CITY OF OREM
DEPARTMENT OF DEVELOPMENT SERVICES

RE: I-15, Utah County – Salt Lake County Final Environmental Impact Statement (FEIS) Comments

RE: I-15 Draft Environmental Impact Statement (DEIS) Comments

Re: Comments on I-15 Corridor Utah County to
Salt Lake County, Final Environmental Impact
Statement (FEIS): CEQ#: 2008024

Sheet: HWY-051.1D

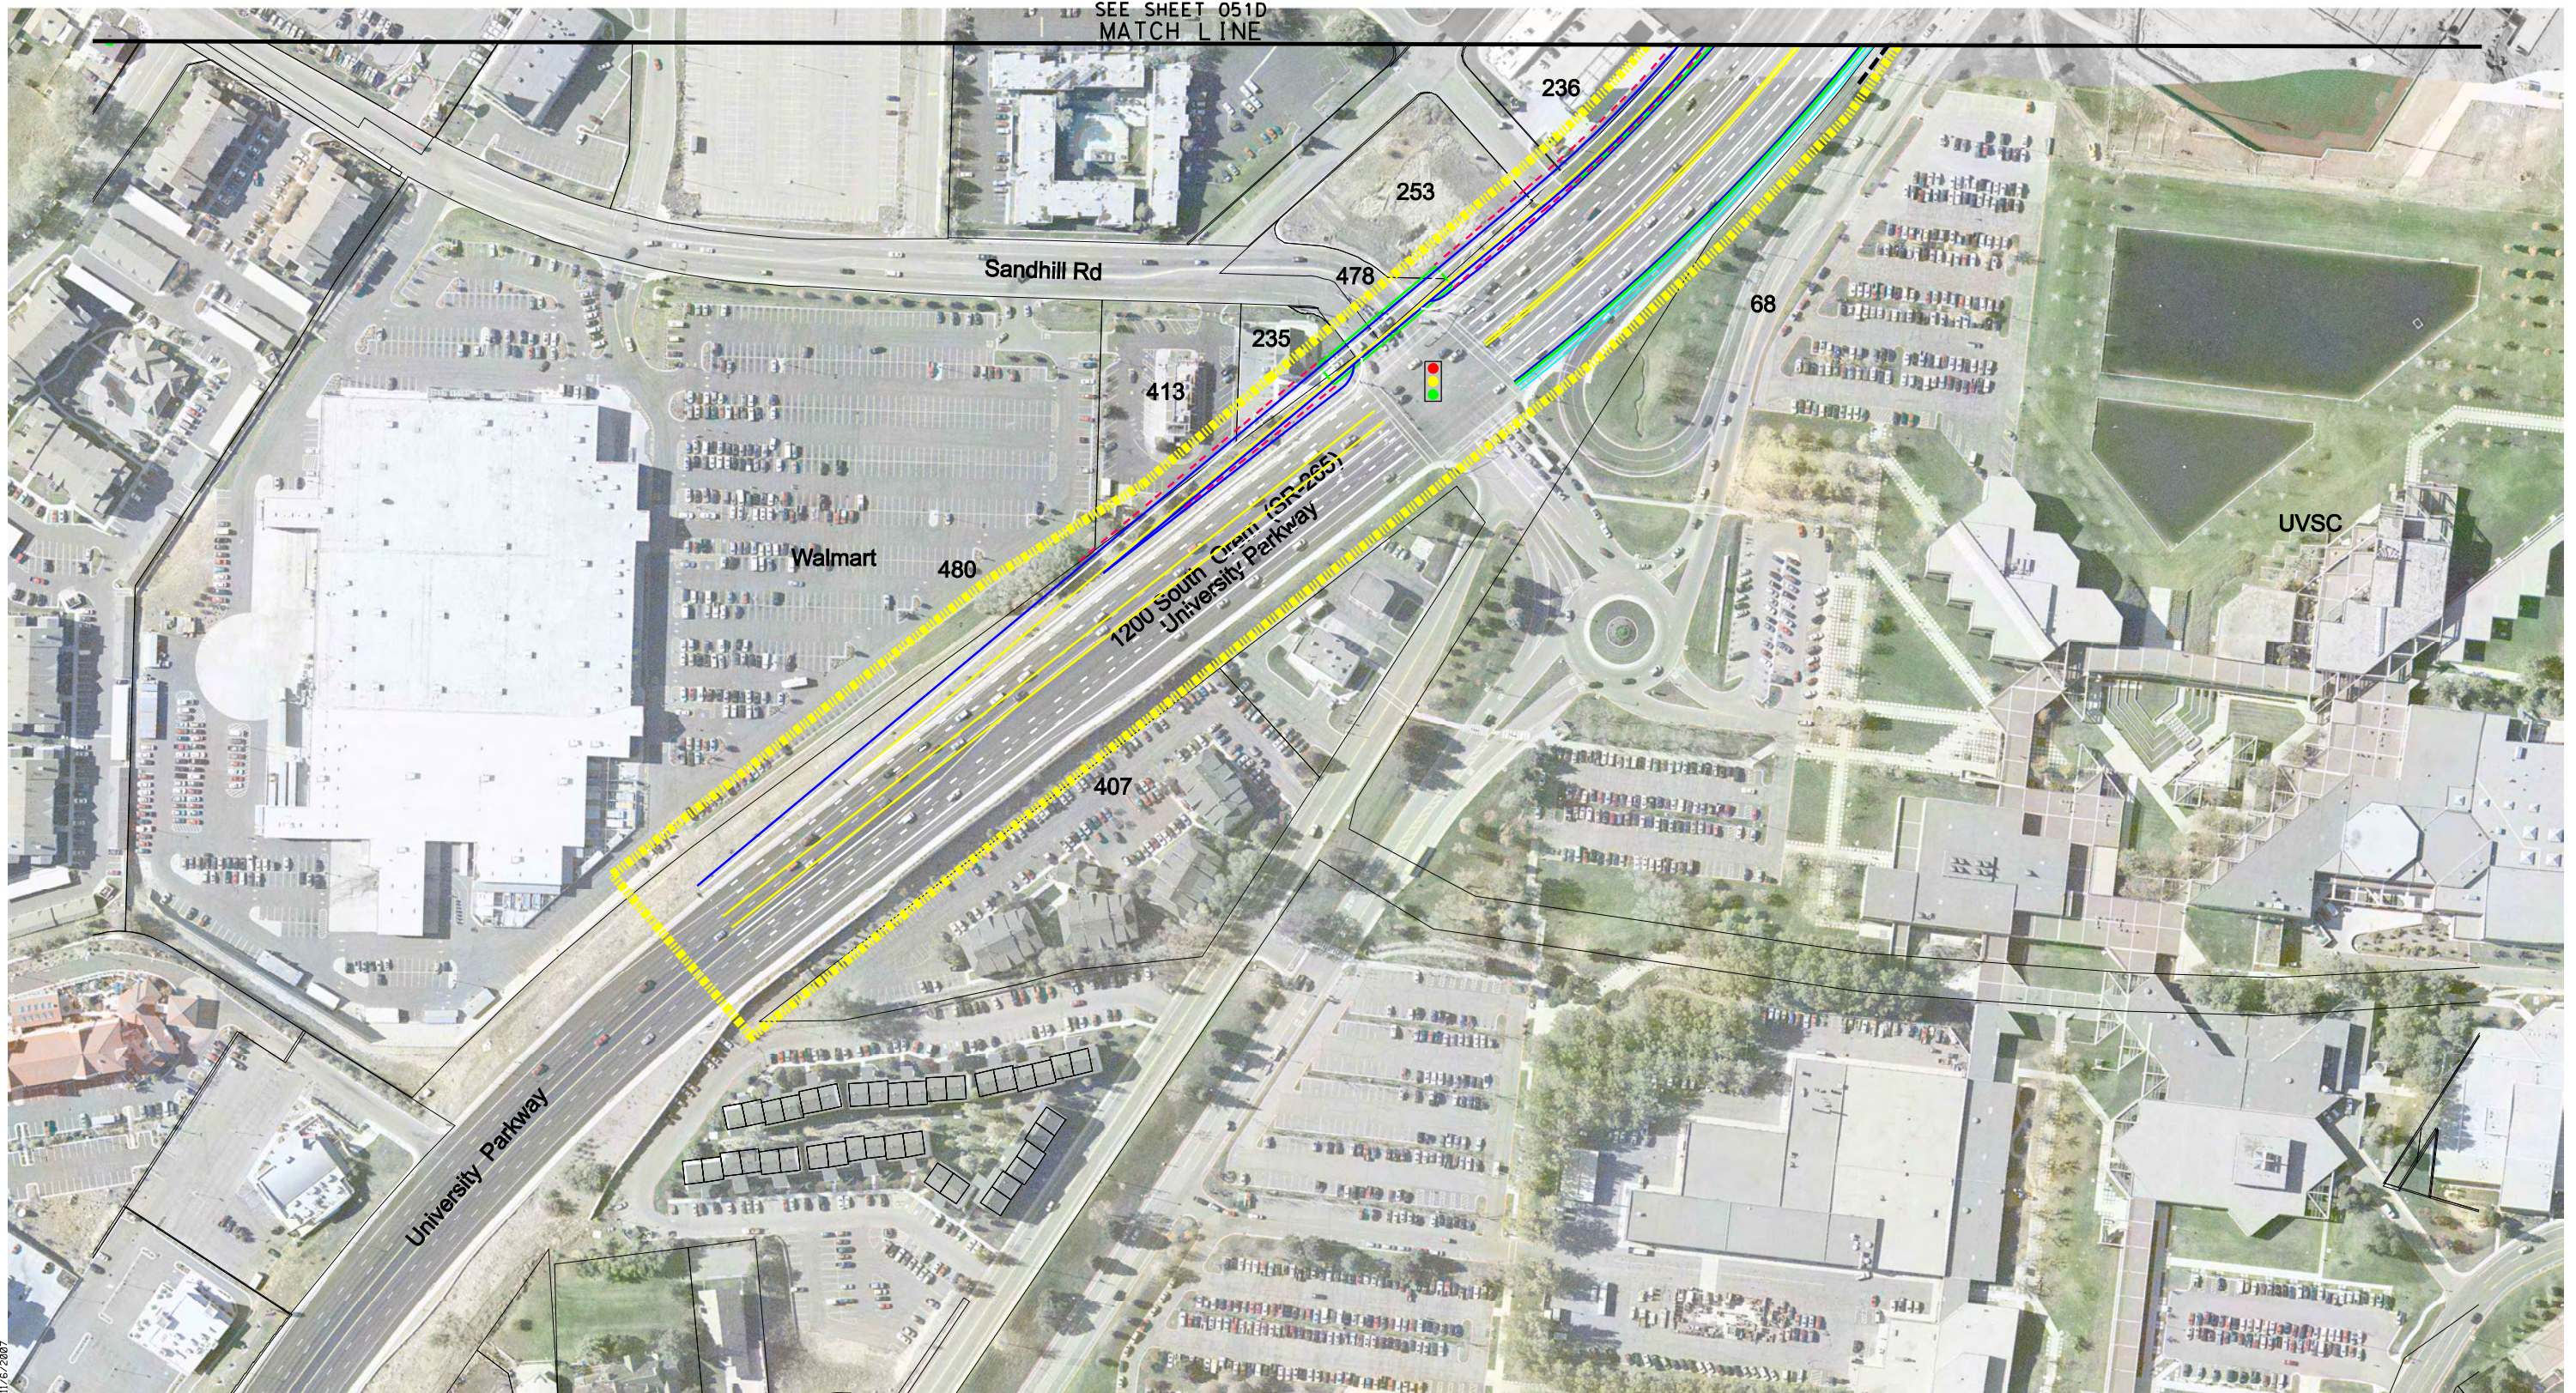
- University Parkway (Vol II, Section: Option D, Sheet: HWY-051D, HWY-051.1D), and
 - 2000 South (Vol II, Section: Option D, Sheet: HWY-049D)
